Change in the Country of Origin Marking

MELSEC iQ-R series, MELSEC-Q/L/AnS/WS series, CC-Link, CC-Link IE Field Network

FA-A-0112-D

1.1 Packaging Box

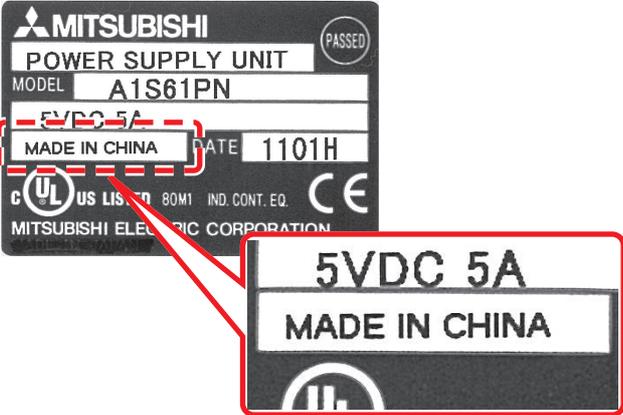
The following shows the examples of marking on the packaging box. There are two types of marking: sticker type (example 1) and printed type (example 2).
